Review of Revised Major Project Concept

Australian Catholic University

Application No.: MP10-0231

Prepared By: Dickson Rothschild

July 2012 shadow diagrams

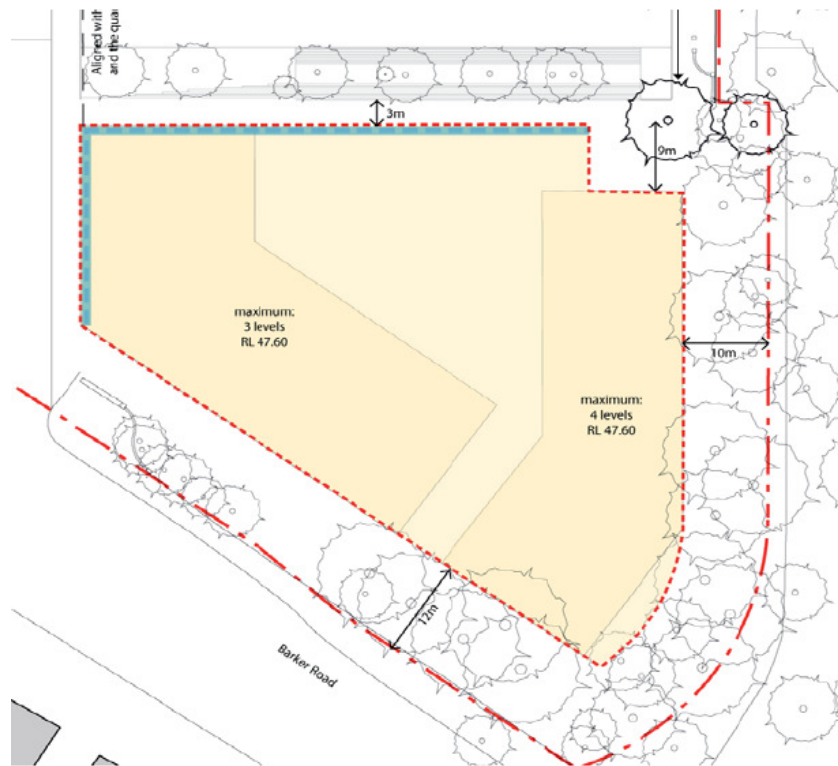
The precinct plans demarcate the “building envelope line” at the perimeter of the building. The 3D massing diagrams include “ghosting” consistent with the building envelope line on the plan and the shadow diagrams indicate simple blocks devoid of breaks in the façade or ground level courtyards. The section and the pale yellow shaded area in the plan appear to indicate a courtyard level although the character and form of the courtyard is not well defined.

Section A-A (top) and Section B-B (bottom) Precinct 1 July 2012

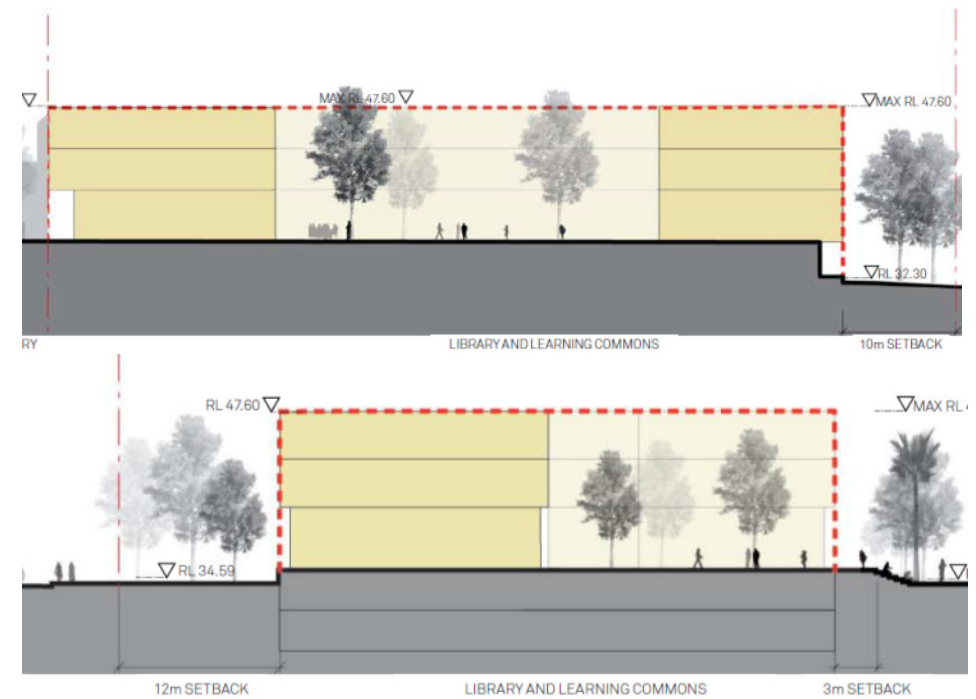
- b) Section B-B and Elevation C-C indicate basement car parking. Section A-A does not identify the access point to basement car park for the precinct. These inconsistencies give rise to questions about how the proposed building envelope is defined and do not make clear the nature of the built form for which approval is sought.

Photomontage indicating scale of Precinct 1 from Barker Road (Source: Dickson Rothschild)

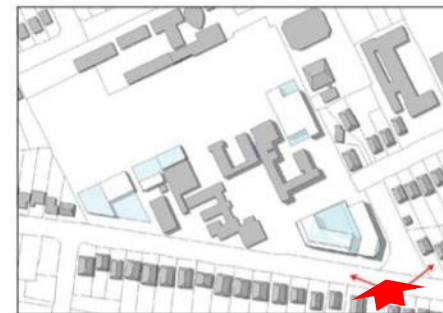
- d) The length of the proposed building remains excessive and the built form when viewed from the public domain will be monolithic.

Car Parking Plan (July 2012)

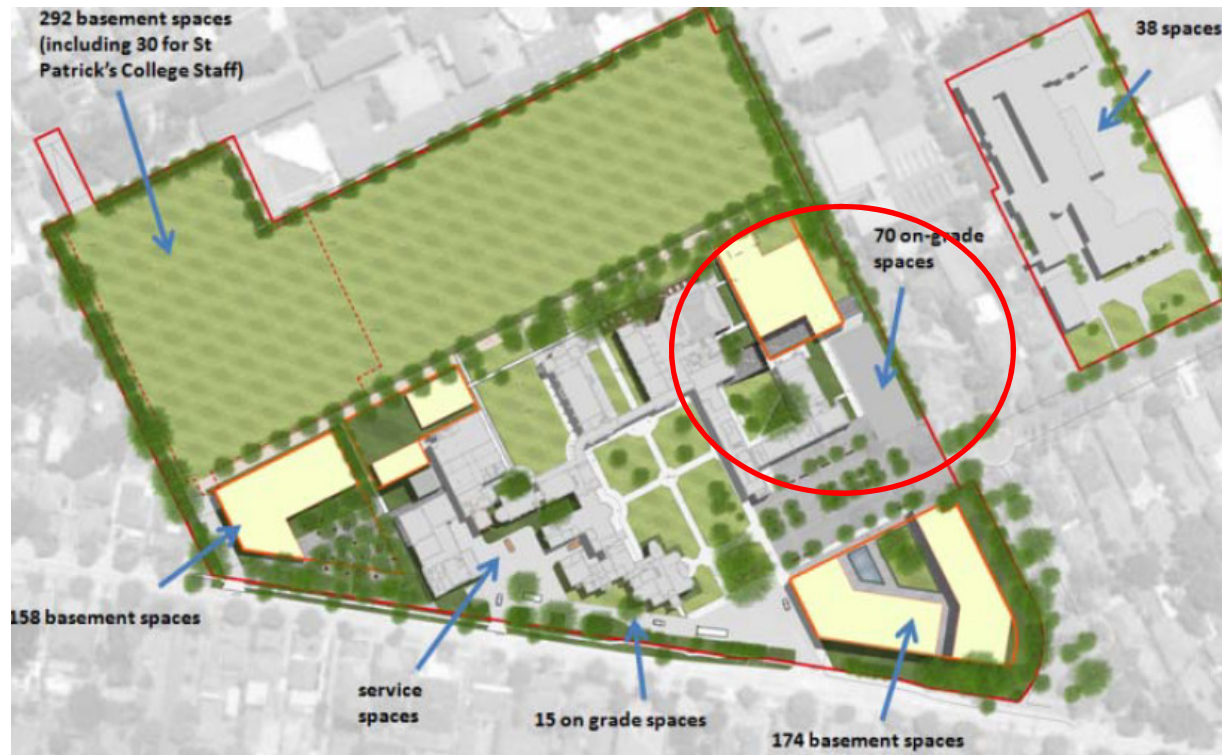
No modification to the proposed building envelope is sought in Precinct 2. However, it is proposed that 70 additional car parking spaces on grade on a paved area adjacent to Precinct 2 will be created. This modification requires the elimination of a large landscaped area and which adversely affects the existing, generally low amenity character, of this portion of the campus.

Section A-A (July 2012)

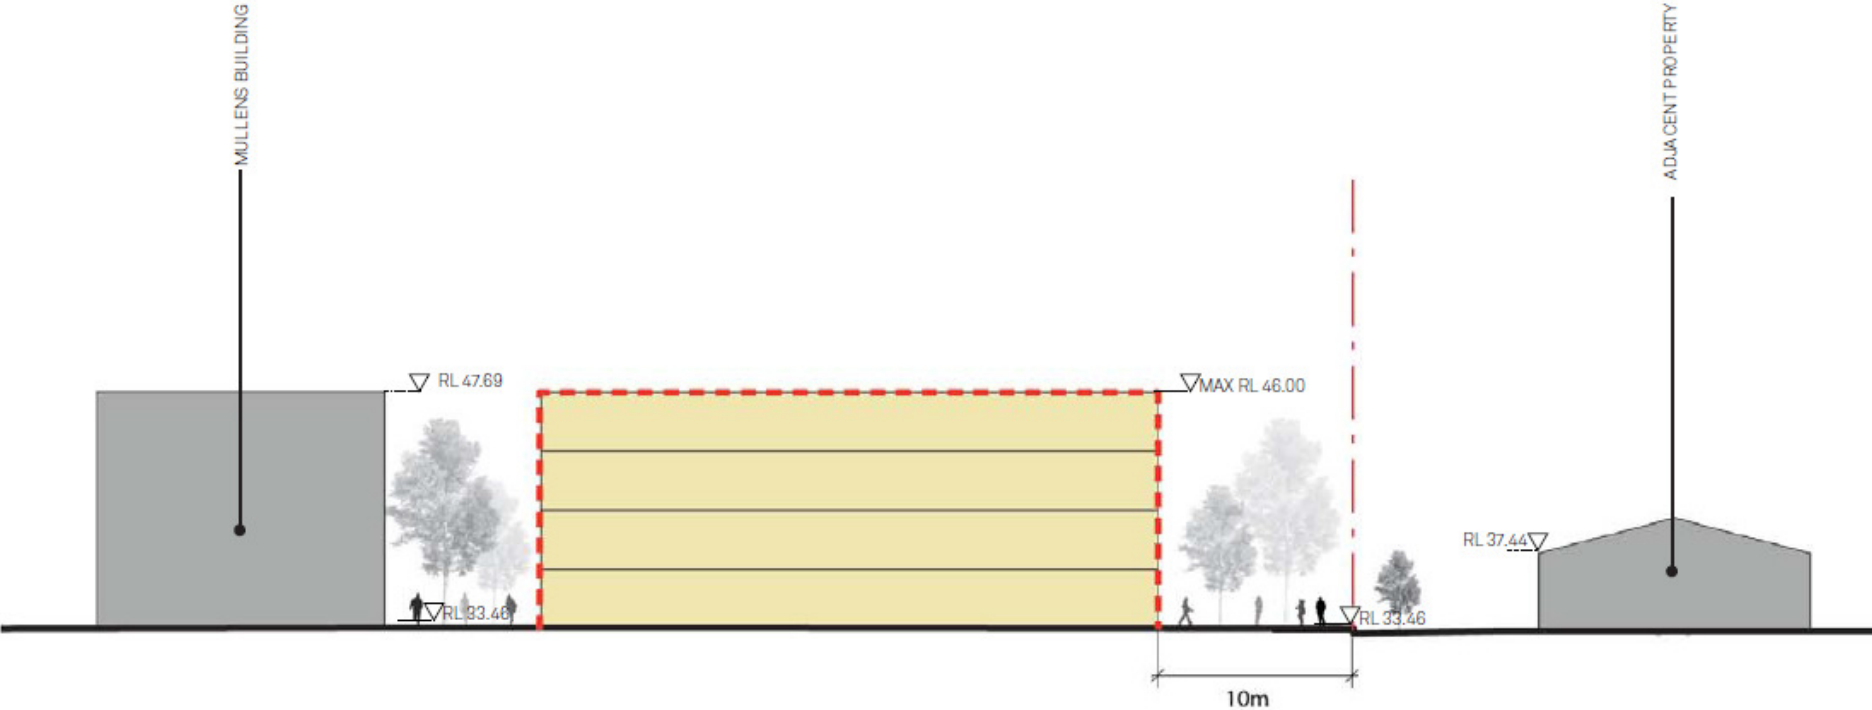
- a) It is noted Section A-A indicates a maximum RL of 46 for the proposed Precinct 2. The section indicates the adjoining building is to a maximum RL of 47.69. However, the section drawings indicate the two buildings being the same height. Further, the Mullens Building, which has pitched roof forms, appears to be shown inaccurately.
- b) Further, there appears to be inconsistencies with the RLs indicated on surrounding buildings. The RLs for the surrounding precincts appear to be taken at the ridge of the pitched roof. In the sections for Precinct 2, the RLs are indicated at the eave or parapet height rather than the ridge. The section drawings do not accurately represent the relationship between the proposed built form and the existing built form.

July 2012 shadow diagrams.

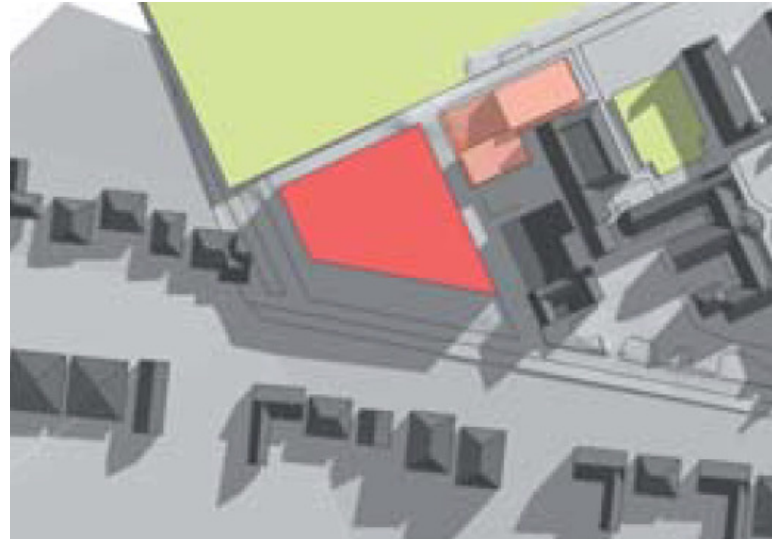
- c) The “ghosting” effect on the 3D envelope analysis, the demarcation of the building envelope line at the perimeter of the building footprint and the shadow diagrams create an ambiguity. These inconsistencies give rise to questions about how the proposed building envelope is defined and do not make clear the nature of the built form for which approval is sought. The ambiguities together with the various representations of the building call into question the character of the proposed interior space of the building.

- d) The shadow impact analysis does not accurately describe the shadow impact on the proposed south-facing courtyard for Precinct 3.

Proposed driveway configuration as illustrated in the Parking and Traffic Study by ARUP (July 2012 scheme)

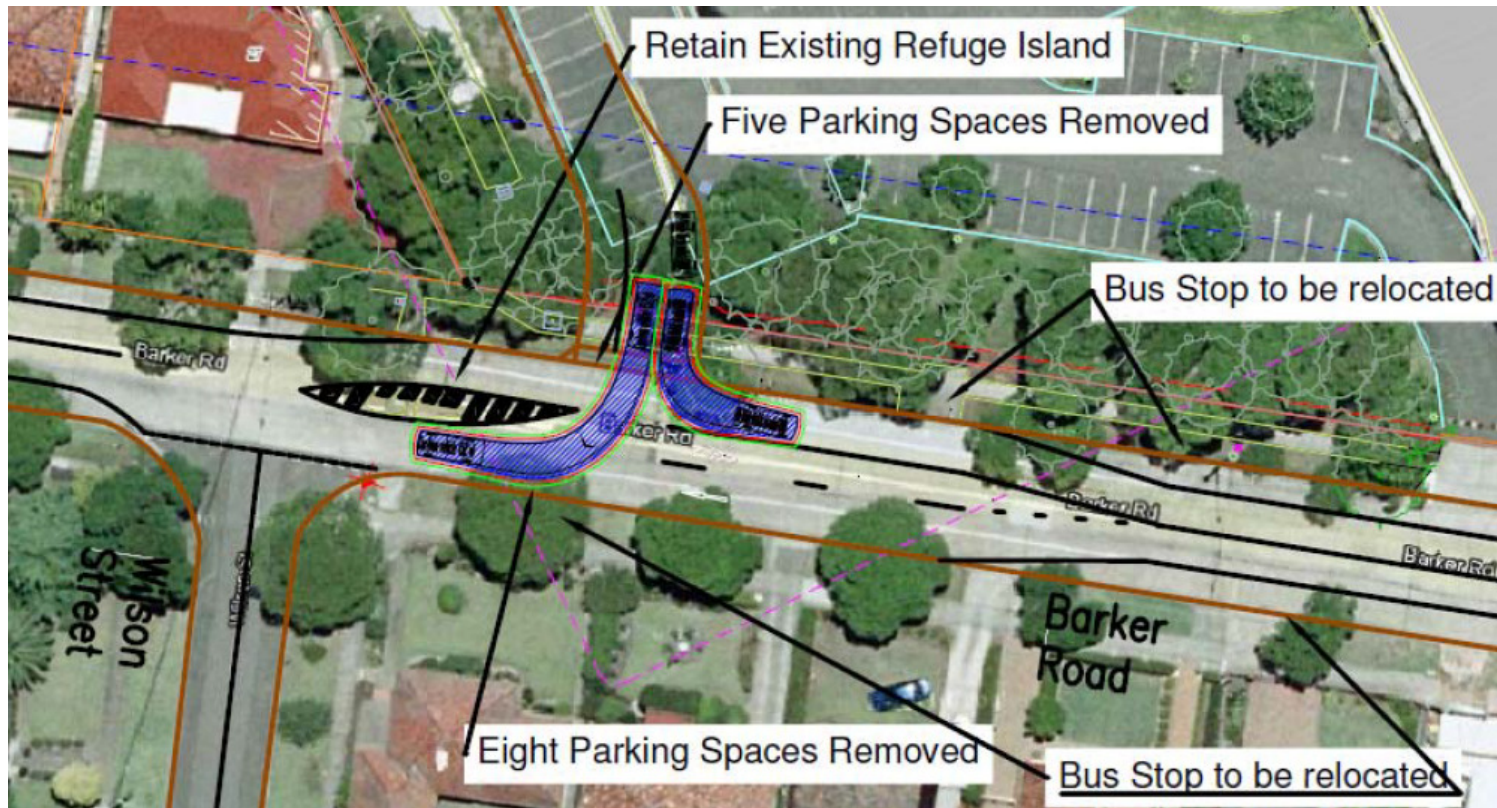
- j) While the western setback has been increased by 5m, it is unclear how acoustic, visual and odour impacts (from exhaust) on the adjoining residents shall be buffered and mitigated. Given the western setback is utilised as the single entrance and exit to the underground car parking for 420 cars (Precinct 3 and Parking under Playing Fields), it is our opinion the proximity of the driveway to existing low density residential development will greatly impact on the amenity of those residents.
